Our Ref: 20227

**RE: MEDI-HOTEL DEVELOPMENT 28-32 SOMERSET STREET KINGSWOOD
DA22/0326 RESPONSE TO ISSUES – TRAFFIC**

Attachment – Car Park Review (File 20227CAD022-220328-CAR PARK REVIEW-13.pdf)

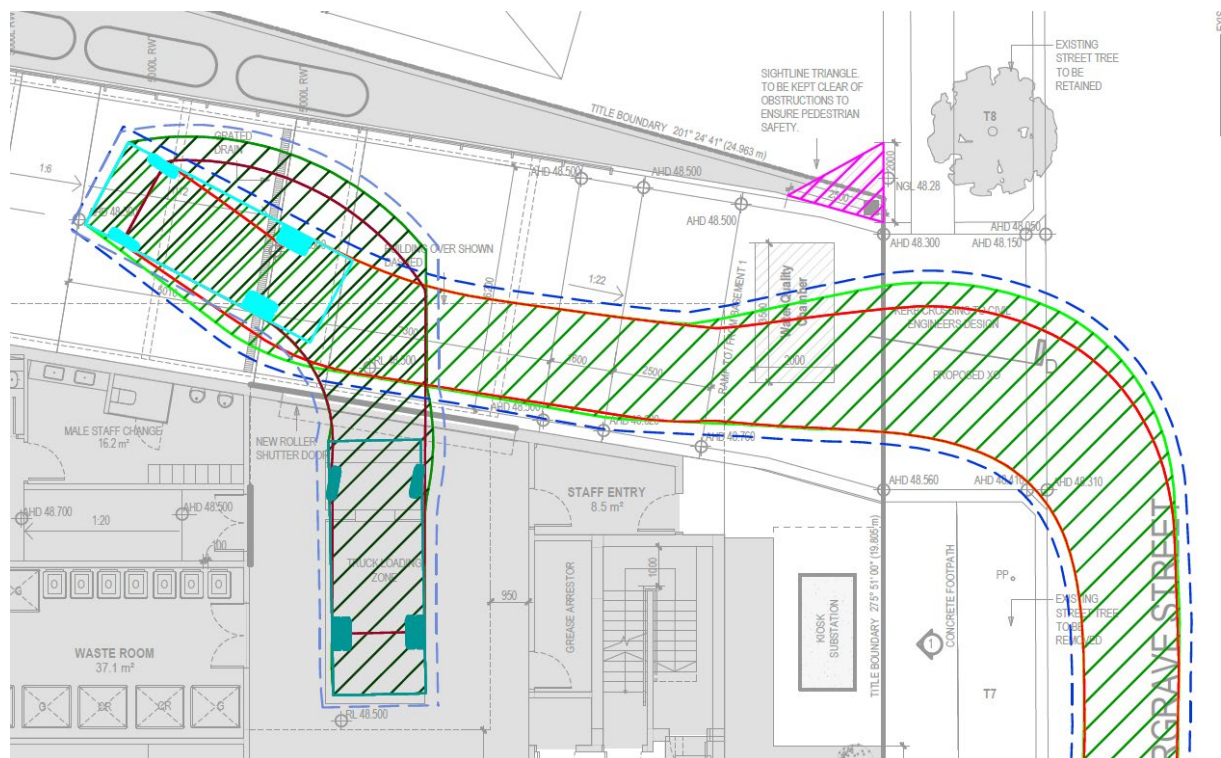
The proposed loading area requires reversing within the carpark/circulation roadway area. This presents a safety concern and may create conflict between servicing operations and visitors/staff, thus should not be supported. Manoeuvring of heavy vehicles should be contained outside of the circulation roadway access.

While it is generally preferred that heavy vehicle and general public access be completely separated, the proposed layout is not considered to present a significant safety concern, and has improved sight lines compared with the approved layout with the loading dock on Basement Level 1.

As demonstrated below (from the March 2022 TIA), the proposed layout requires an SRV accessing the loading bay to enter the site in a forward direction, travel on the driveway to a point just past the loading bay before reversing into the loading bay. Before performing the reverse manoeuvre, the driver of the SRV would have adequate sight distance along the driveway to ensure there is no conflict with an exiting vehicle. There is adequate space for the entering SRV to wait clear of any vehicle exiting the basement before performing the reverse manoeuvre.

The driver of any vehicle entering the driveway behind the SRV would have a clear sight line to the SRV before and during the reversing manoeuvre, and there is adequate space for a car to wait in the driveway between the boundary and the loading dock, completely clear of the reversing SRV and the footpath on Hargrave Street. If required, signage and/or linemarking may be implemented on the driveway before the loading dock to advise car drivers to "stop here if truck reversing ahead".

TITLE: CAR PARK COMPLIANCE REVIEW GROUND LEVEL

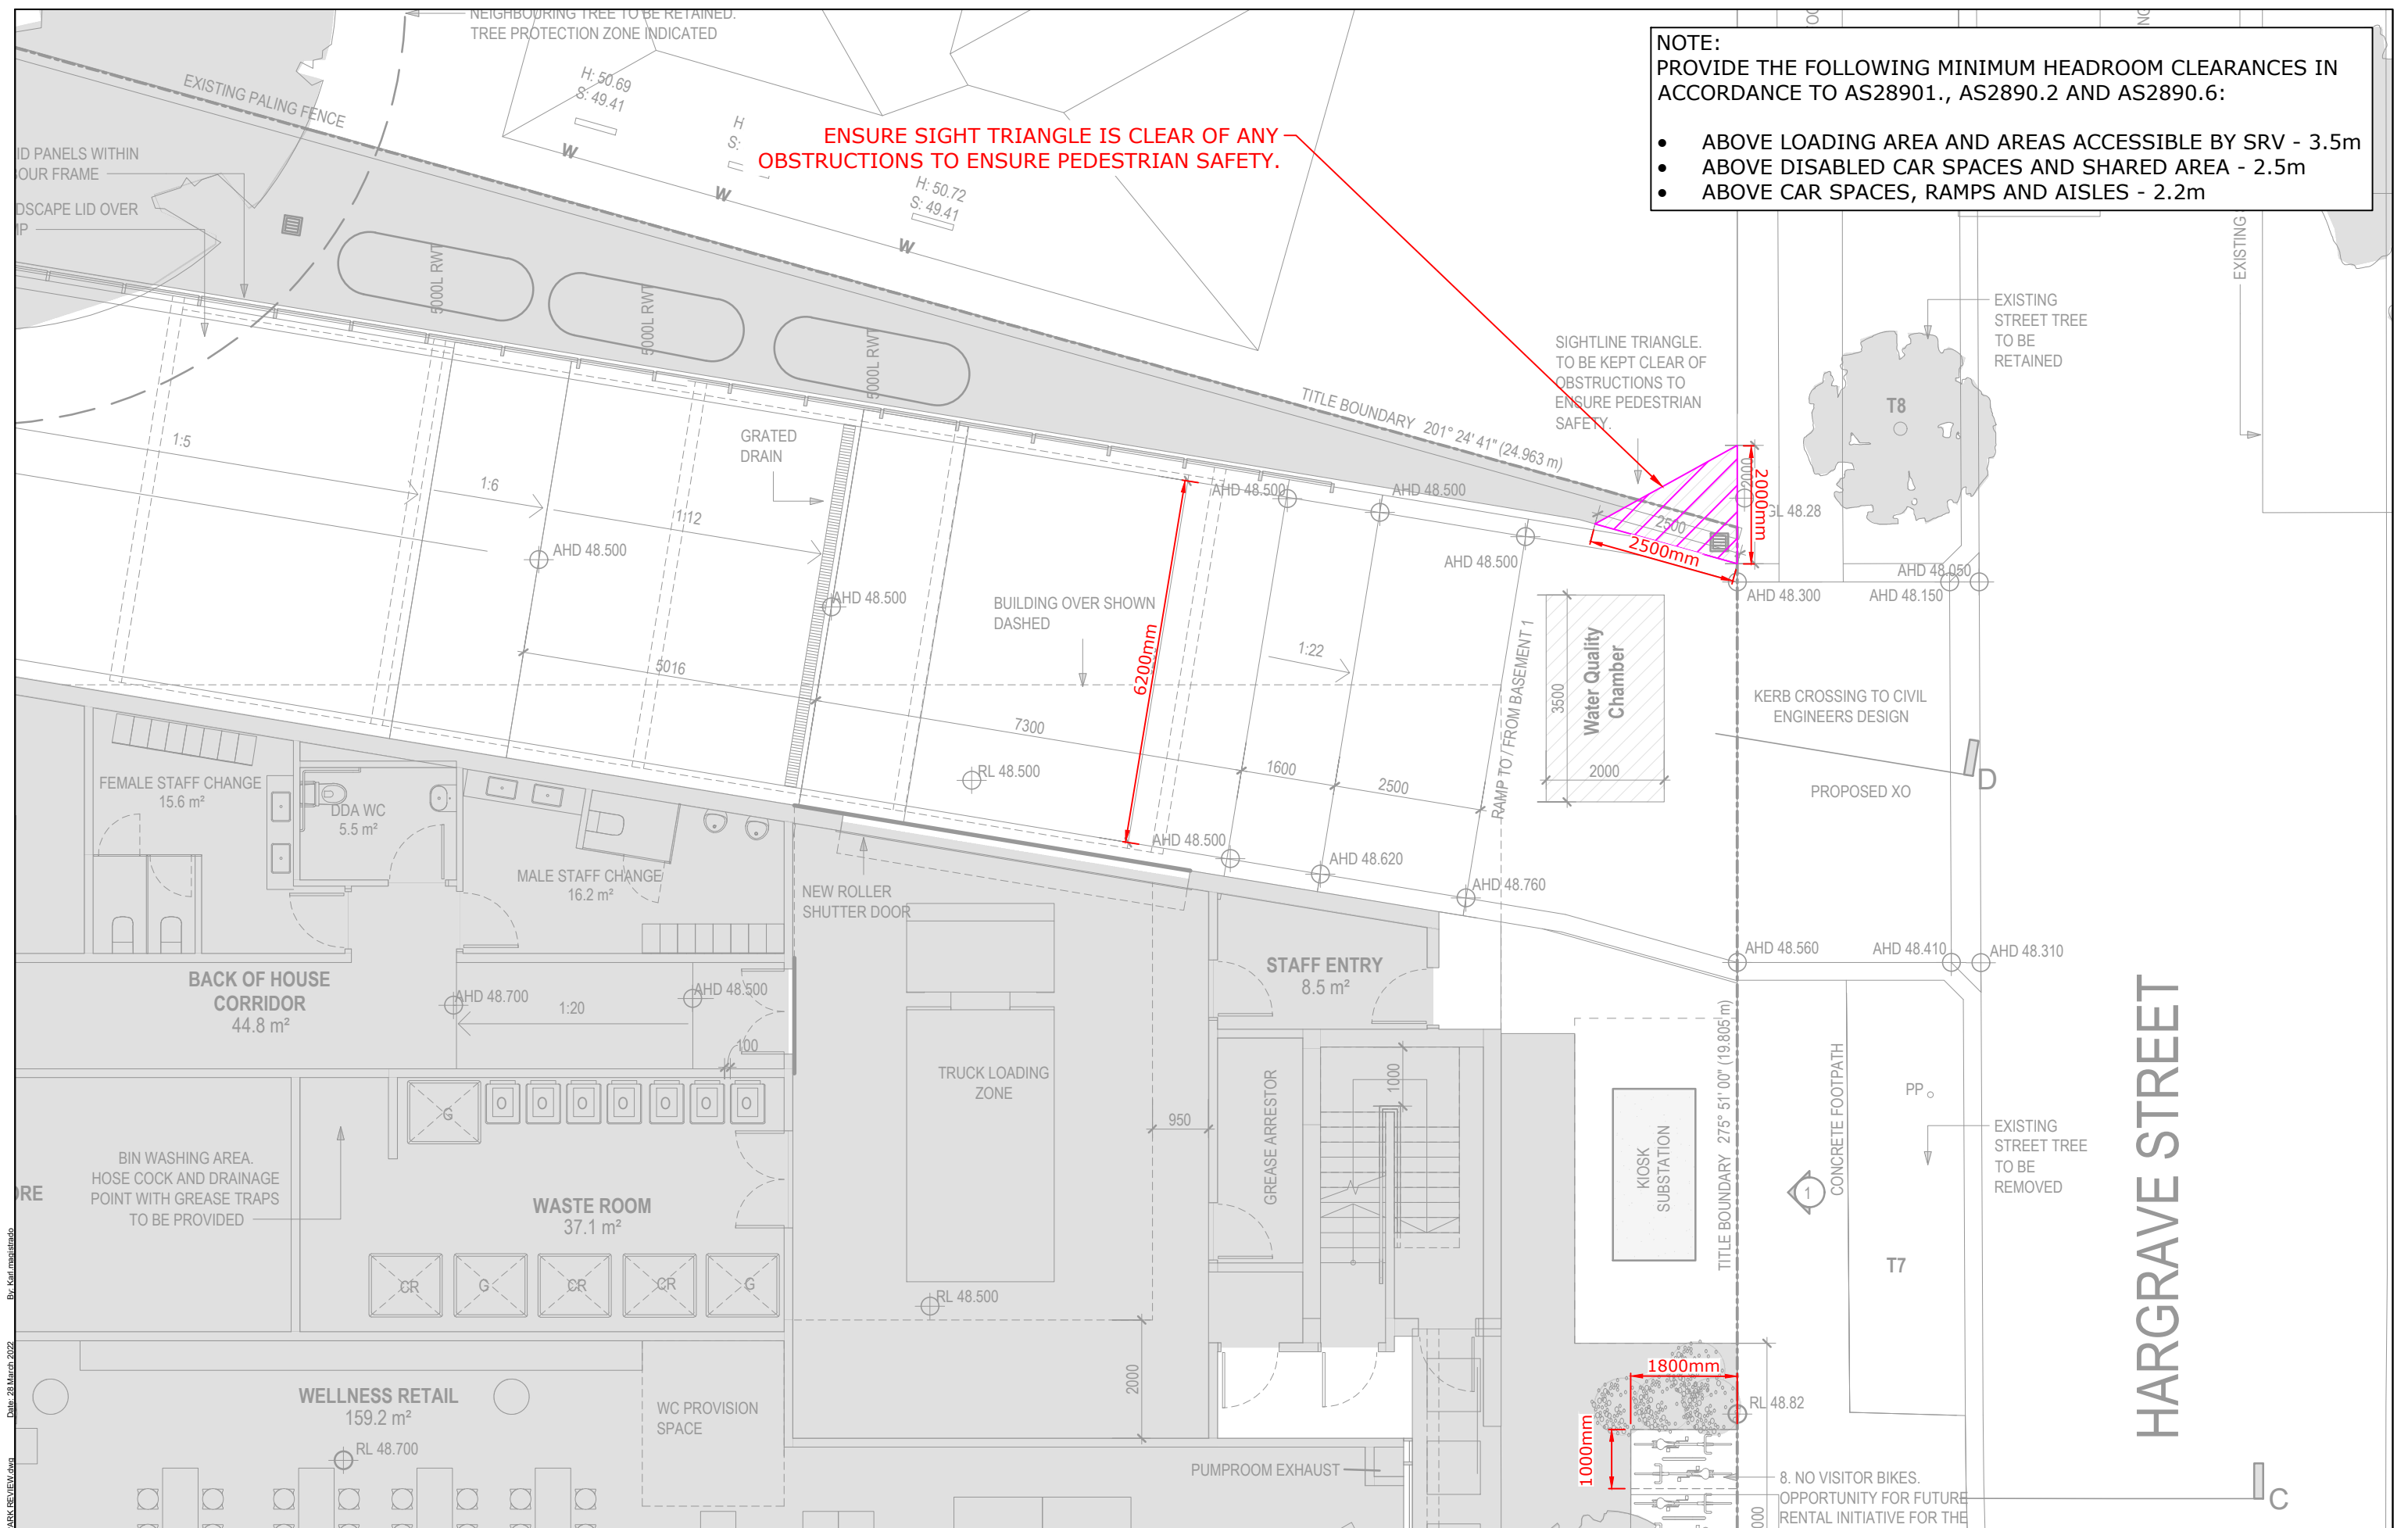
ENSURE SIGHT TRIANGLE IS CLEAR OF ANY OBSTRUCTIONS TO ENSURE PEDESTRIAN SAFETY.

SIGHTLINE TRIANGLE. TO BE KEPT CLEAR OF OBSTRUCTIONS TO ENSURE PEDESTRIAN SAFETY.

TITLE
**CAR PARK COMPLIANCE REVIEW
 BASEMENT LEVEL 1**

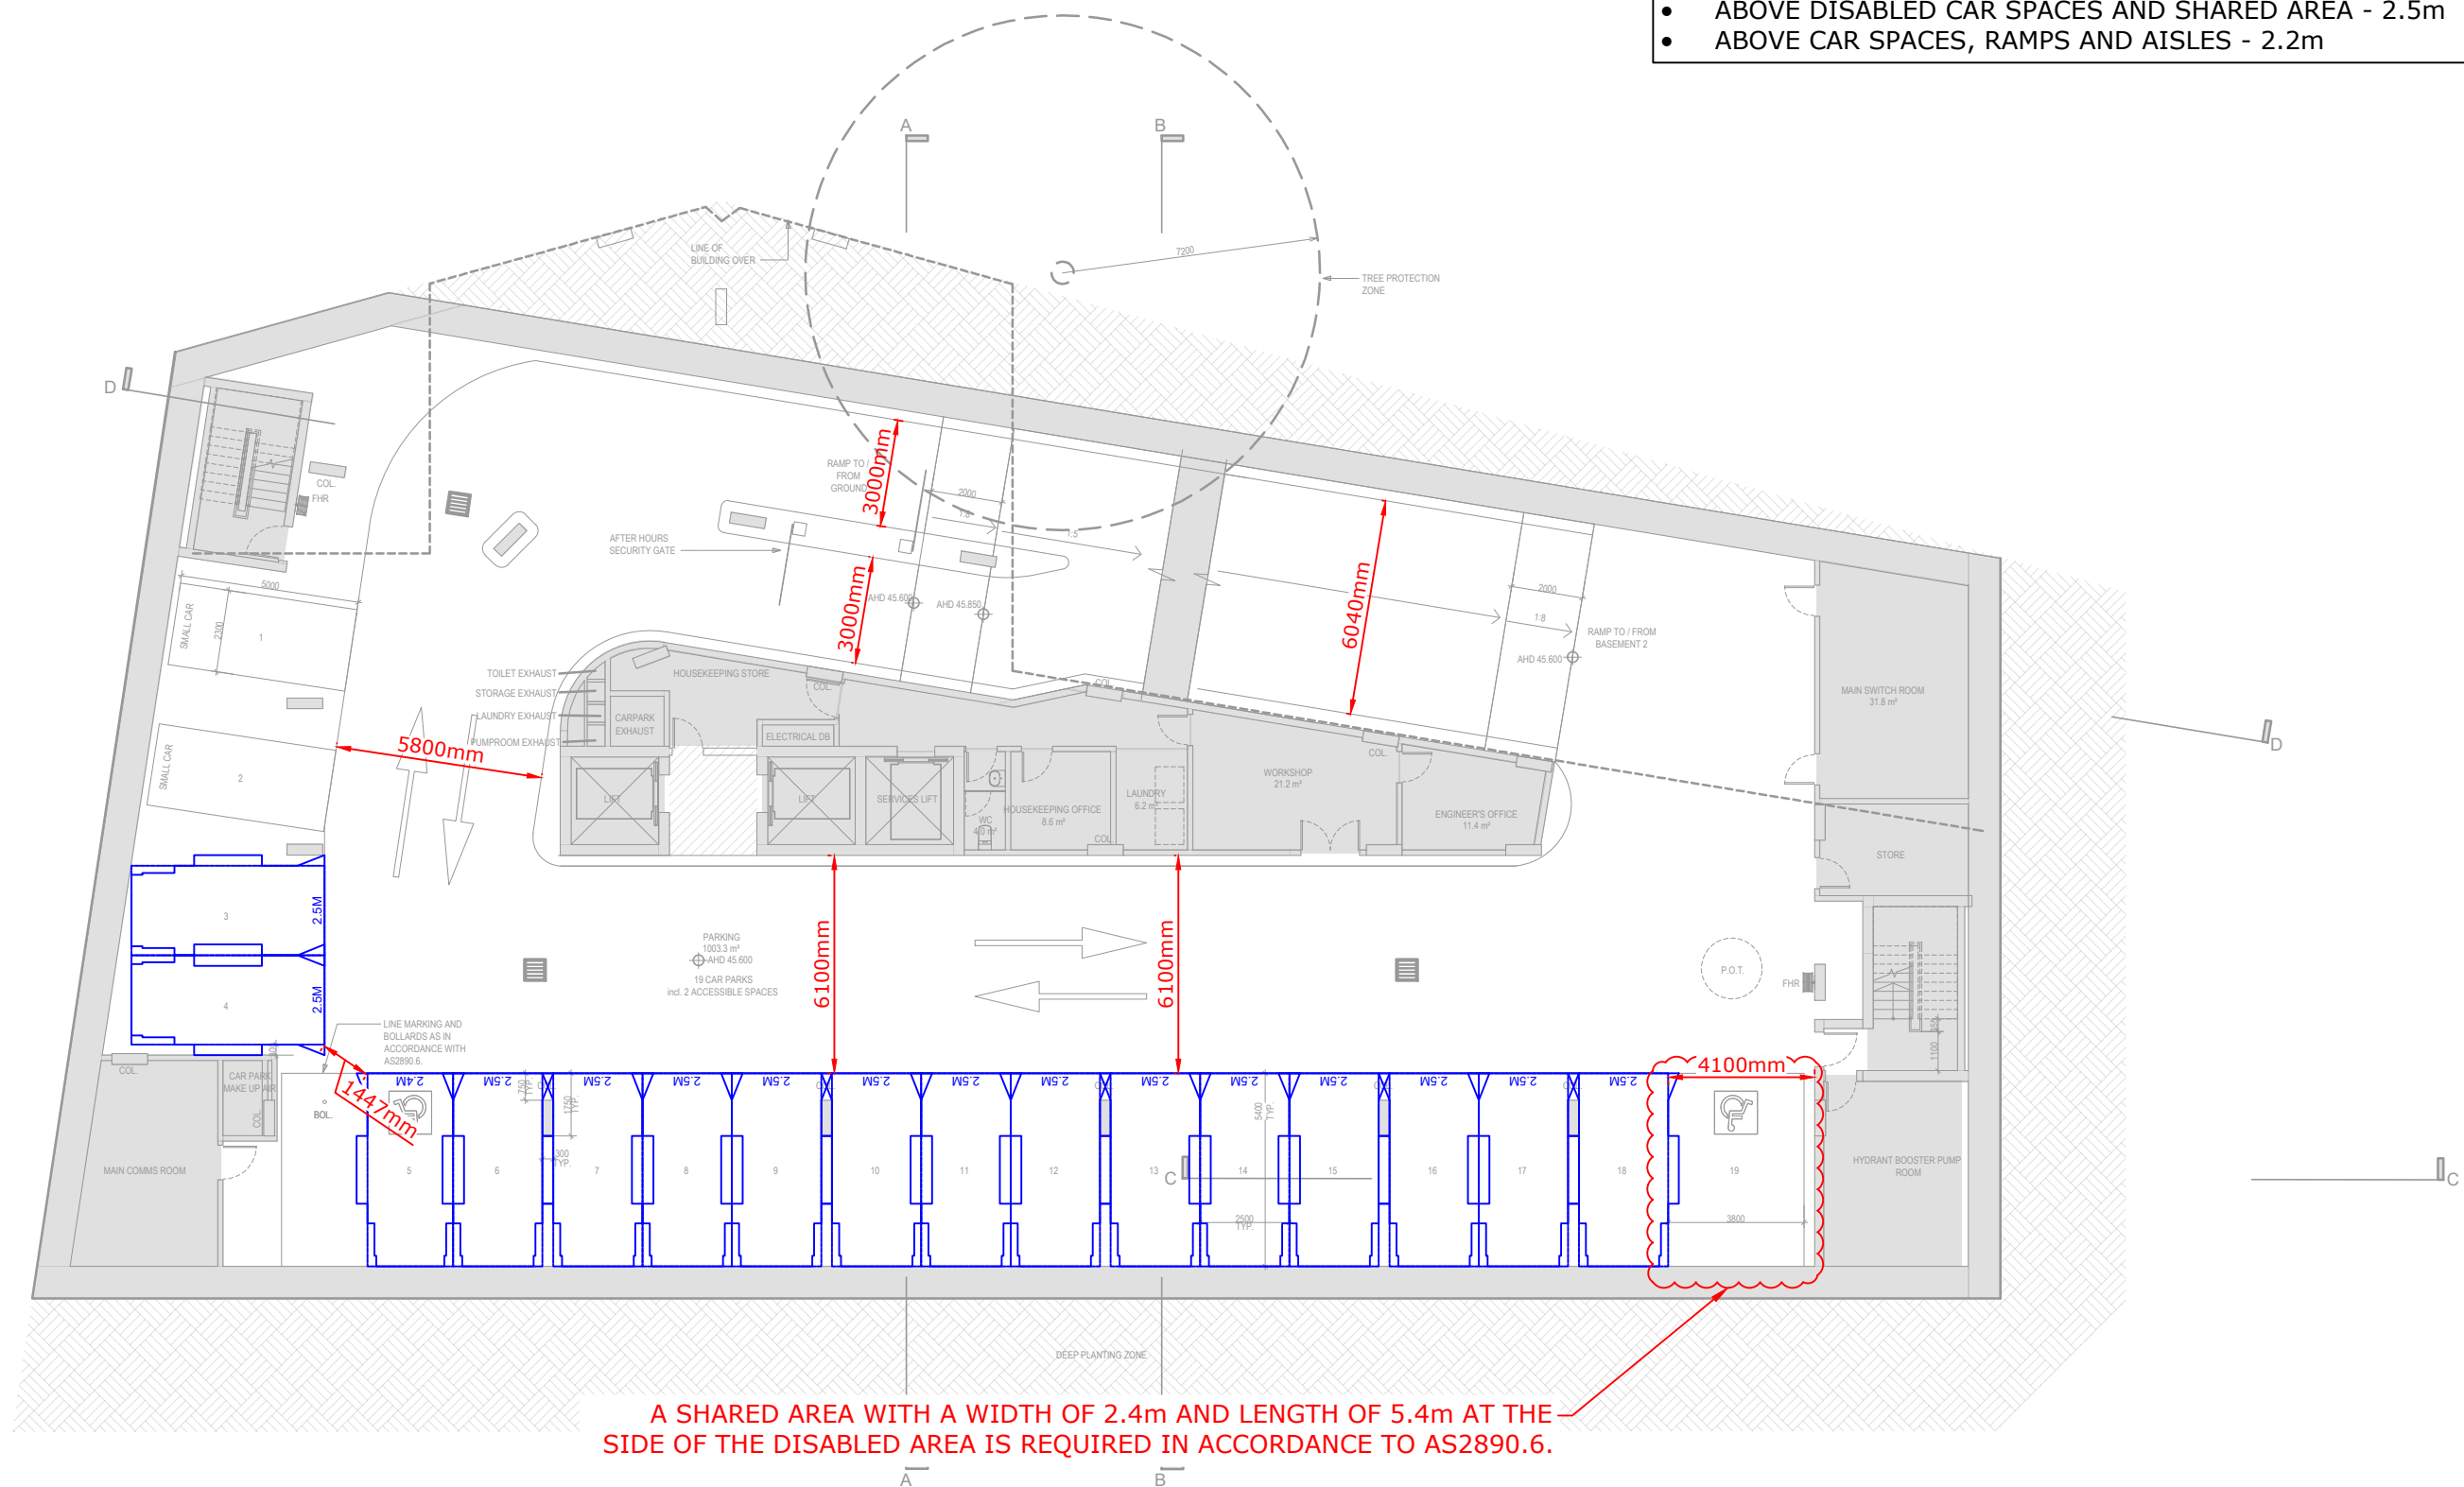
The accessible spaces 38 and 58 must be in accordance with AS 2890.6 and feature a shared space and bollard. Accessible spaces should be co-located to basement level 1 with spaces positioned as near as possible to the passenger lifts.

The parallel parking spaces no. 39 and 63 should be a minimum of 6.5m long in accordance with AS 2890.1 and the disability parking spaces should be a minimum of 2.4m with an adjoining 2.4m wide shared area as per AS 2890.6 and the recommendation of the applicant's traffic engineer, TPPP. The designs should be adjusted accordingly with dimensions provided on the drawings.

A SHARED AREA WITH A WIDTH OF 2.4m AND LENGTH OF 5.4m AT THE SIDE OF THE DISABLED AREA IS REQUIRED IN ACCORDANCE TO AS2890.6.

In the March 2022 TIA report, TTPP acknowledges that these spaces do not comply with the requirements of AS2890.6 for spaces for people with a disability. It is understood that the access consultant has reviewed these spaces with respect to their geometry and location and advised that a performance-based approach demonstrates compliance with the relevant performance provisions of the BCA. TTPP also notes that the layout exceeds the requirements of AS2890.6 for New Zealand, confirming that the spaces are functional and fit for purpose despite not meeting the layout requirements specific for Australia.

The parallel parking spaces meet the requirements of AS 2890.1, being shown on the plans as 5.9m long with 450mm clearance to obstructions on each end, i.e., 6.8m long.
